C2M eye width

Piers Dawe, Nvidia

Introduction

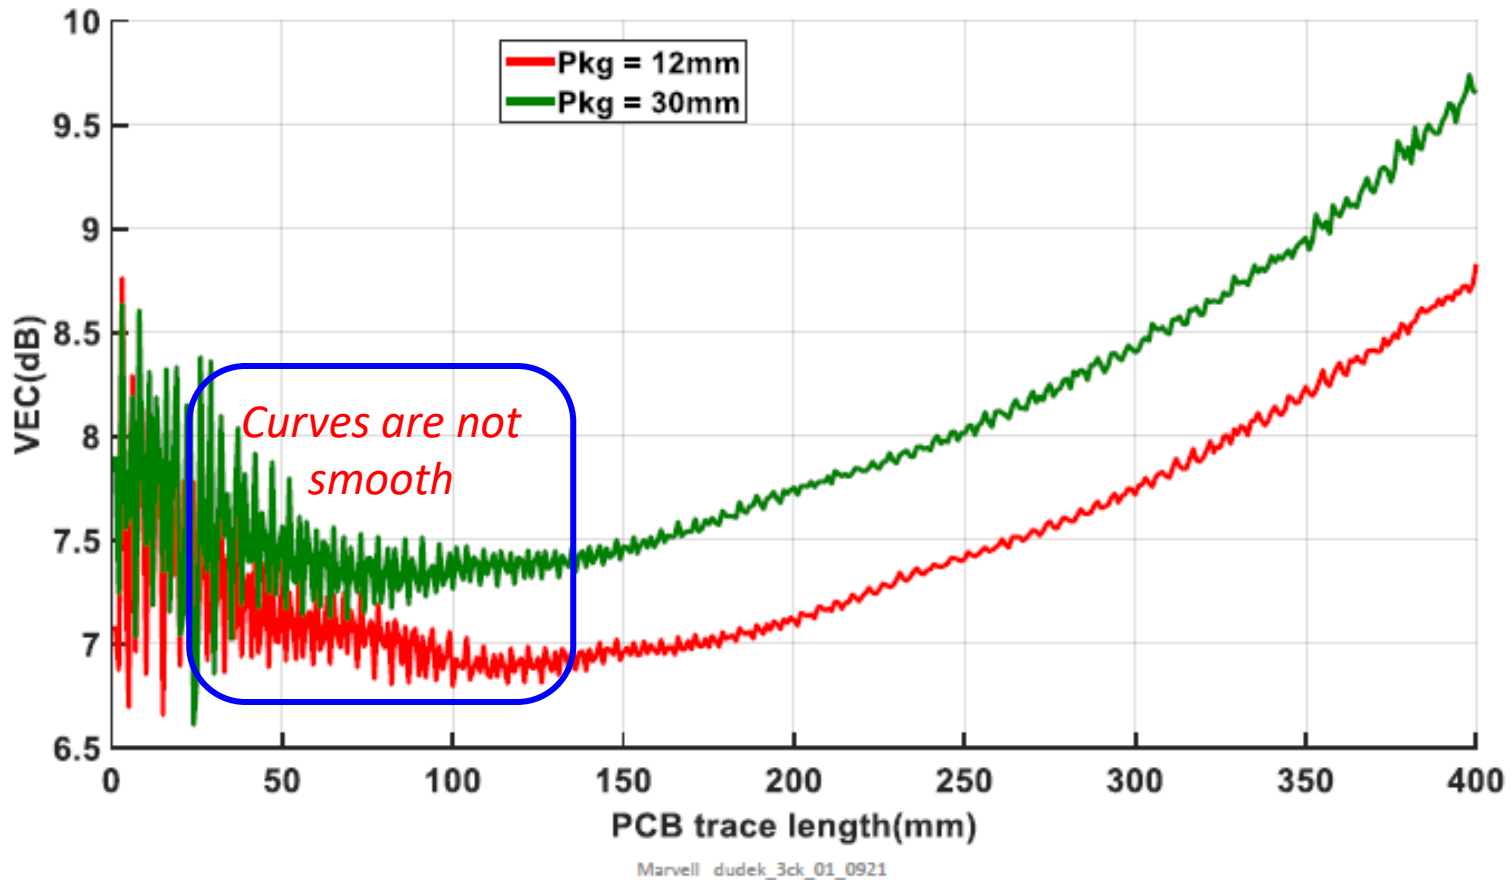
Dots appear in rows, which seem to be channel/package/driver sets

High loss on right (relatively high ESMW), low loss on left (relatively low ESMW)

As none of these is controlled by spec, what excludes other sets further to the left?

Faster package and driver are possible, have not been not explored? With a short channel, they will be to the left

Short channels were shown to be an issue (see next slide)

From dudek_3ck_01_0921.pdf

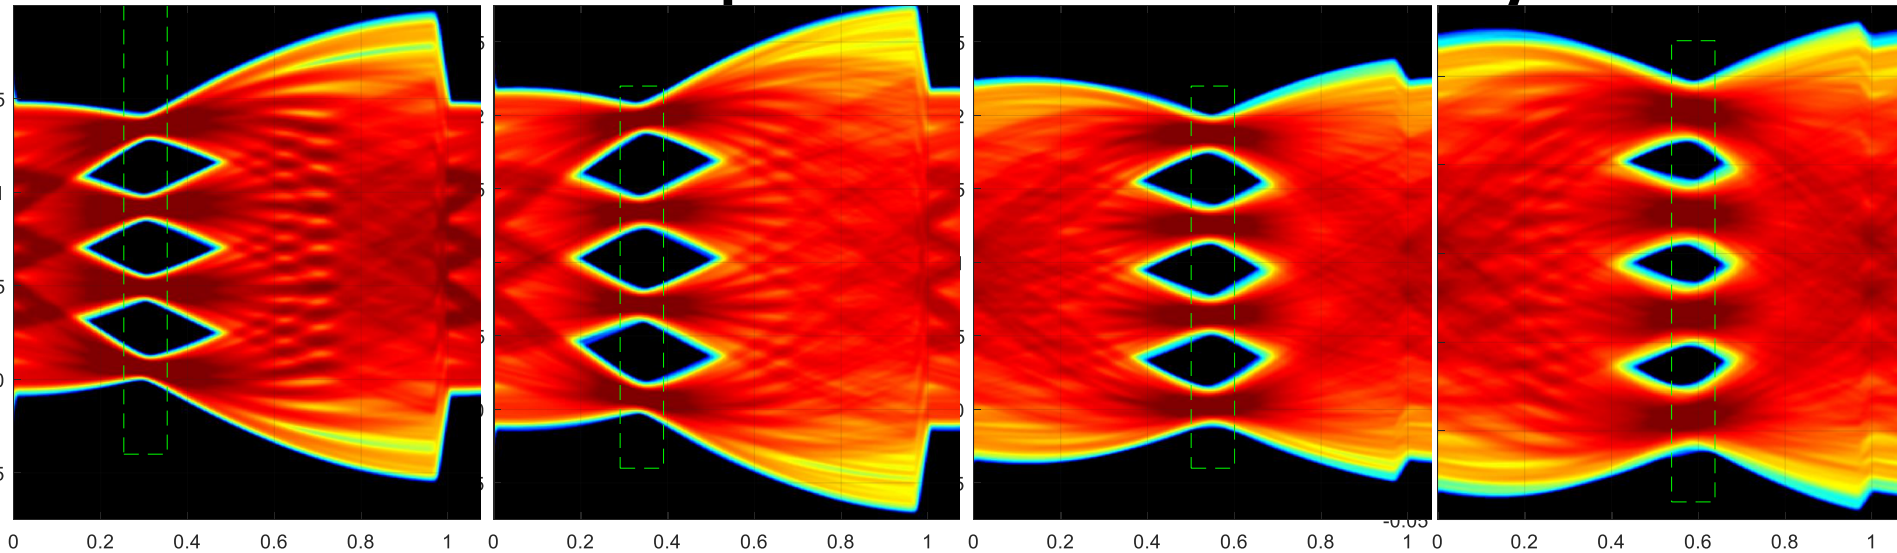
- This shows that small changes in reflection phase make big changes in VEC
- Eye width also changes, but not necessarily in proportion

VEC doesn't predict ESMW very well

1: typical mid-loss host

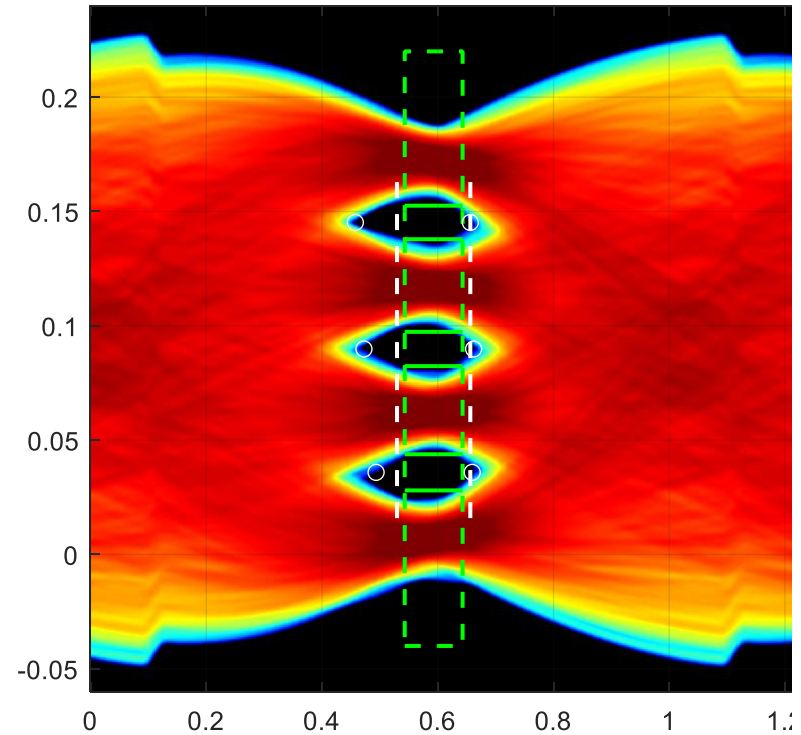
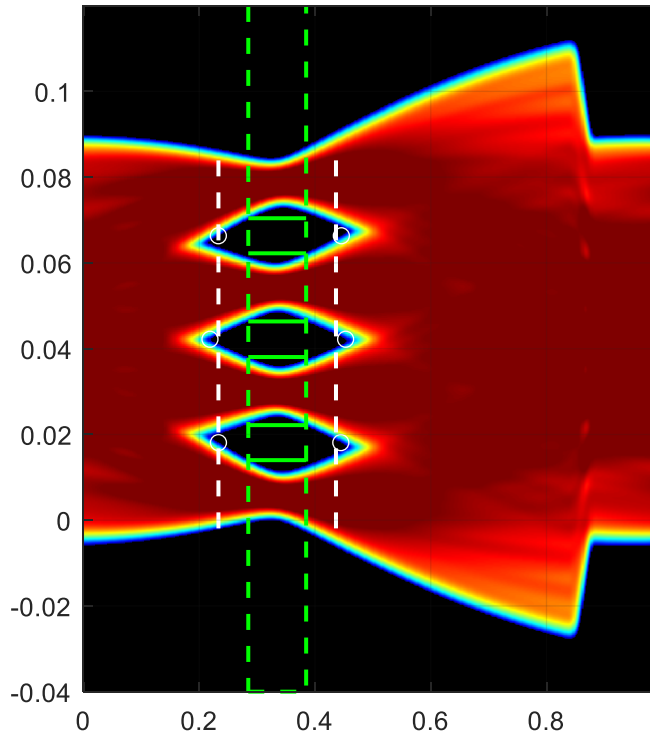
- Eyes at TP1a are simulated with little noise and clutter for clarity, no module reflections. 31 mm COM package, 53.125 GBd. For each signal, VEC and width would vary in proportion depends on edge rate of that signal
- Steepest edges are late sides of eyes in right signals. For the same de-weighted VEC, this signal has worse ESMW
- Eye sides can be curved, further reducing ESMW
- Module output can do this too if not forbidden. Worse signals can exist (e.g. short package, worse reflections...)

Measured "TP1a" signal from pattern generator, loss board and test fixtures

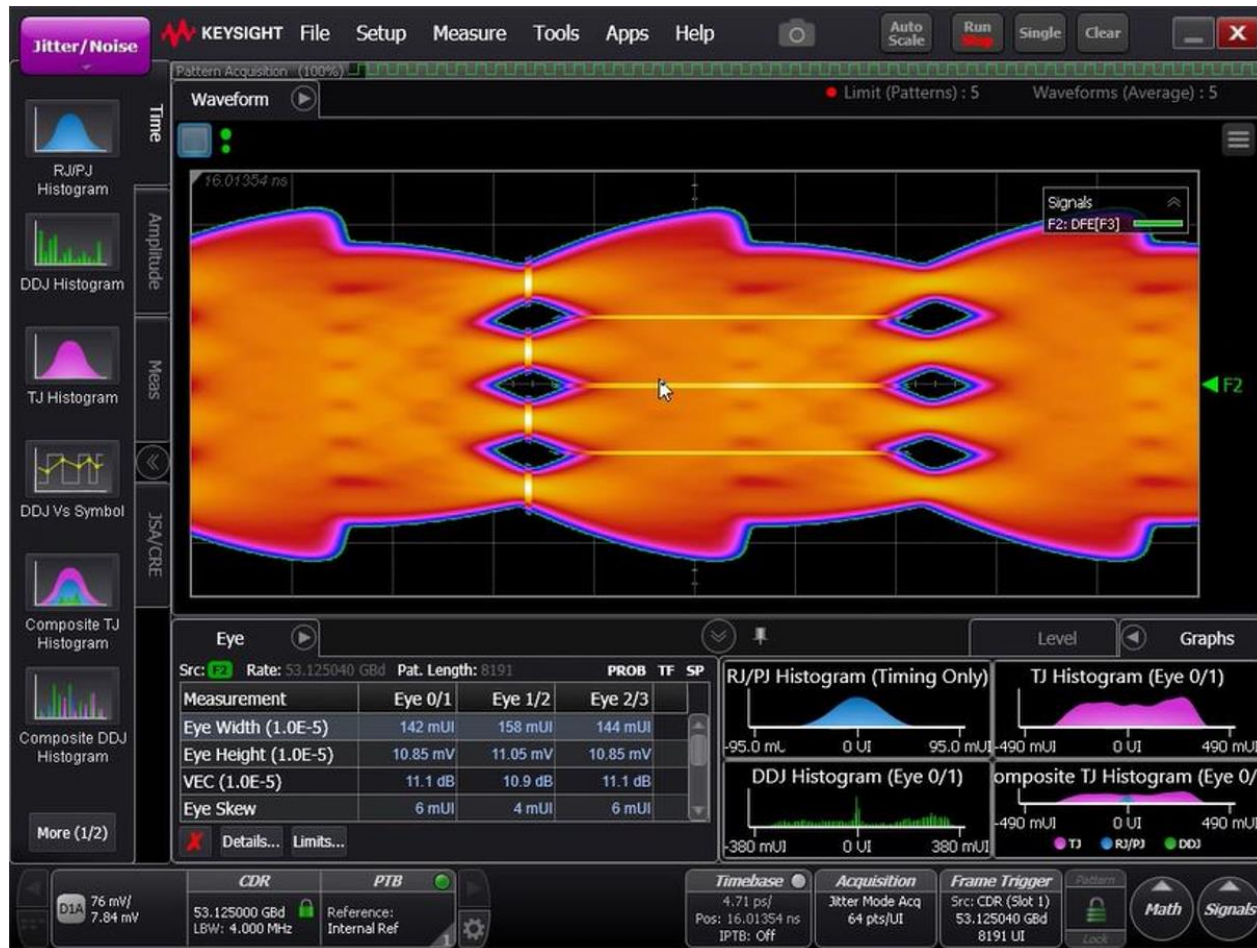
- Eye width is 142 mUI for VEC of 11 dB
 - Implies 127 mUI at 12 dB if eyes are diamonds, slightly more if curved
 - This is less than any of the COM predictions, and this "host" has good reflections and crosstalk; a barely compliant one could be worse

- Eye opening can be enforced by:
 1. +/-50 mUI histogram without weighting = 0.1 UI wide rectangular mask
 2. 10-sided mask as proposed previously
 3. ESMW spec as in 120E
- Option 3 is less satisfactory but familiar and already provided in oscilloscopes
- Proposed limits:

R2-19	R2-17	Unit
Host output / module input (TP1a)	135	120	mUI
Module output / host input (TP4)	185	130	mUI
